Subject: RE: Public comment letter- Gwynne Aidala case 2024-00337 additional comment

Case No. 2024-00337

In reference to data submitted by Wood Duck Solar, referenced in the <u>Review and Evaluation of the Wood Duck Solar, LLC Site Assessment Report</u>, from Harvey Economics,

Exhibit 5-6. Predicted Sound Contours of the Wood Duck Solar Facility during Daytime Operation, dBA:

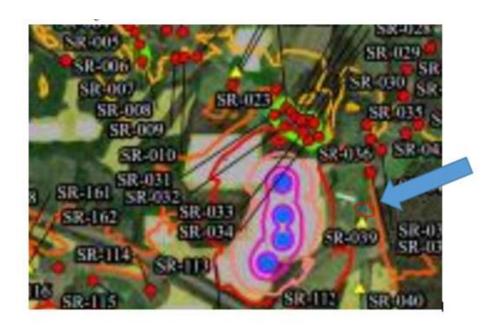
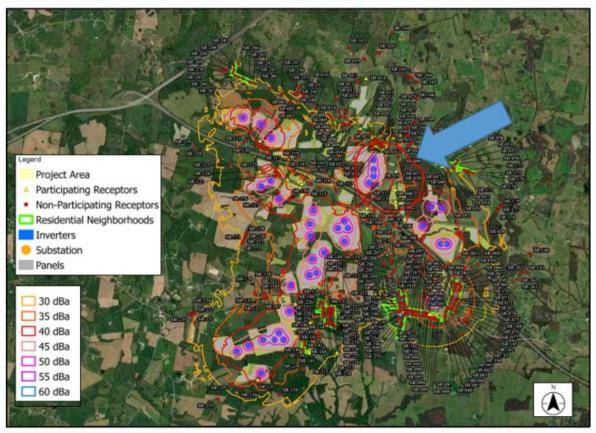
It does not appear that the list of Non-Participating Receptors is fully represented. As described in the paragraph on page 54:

There is NOT a "Non Participating Receptor" red dot at that location on the map below and therefore, data regarding noise impact to my home/business would not have been considered. If I am not included, how many others are not included?

Zoomed in view: I have circled the location of my property below
